## Index 646-001 Aluminum Pedestals and Posts – Pedestrian Detectors and Signals

New Index:

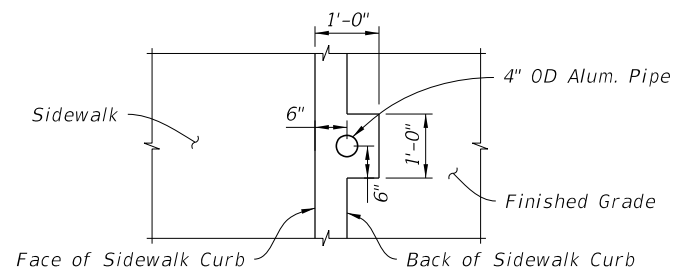
- 1-Recommend to make Plan View, Section A-A proportionate; add label for 'sidewalk curb'; show post placement dimension in other direction.
- 2-In the title change to ".....Pedestal Mounted.....".

**RESPONSE:** Agree with both comments.

**Changes made to Index:** Section A-A has been proportionality corrected, post placement dimension in both directions added, and title corrected.
